Access Compliance Report

Public Rights-of-Way

(Pedestrian Signals)

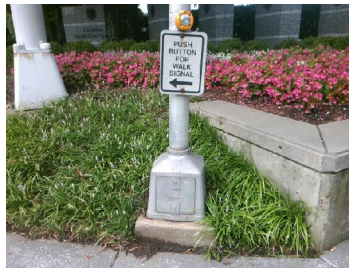
PROW/ADA: TMUTCD 4e.08, R404.2, R406.2

Possible Solutions: Replace Signal Push Button With APS Button on New Post. Remove & Relocate Sign.
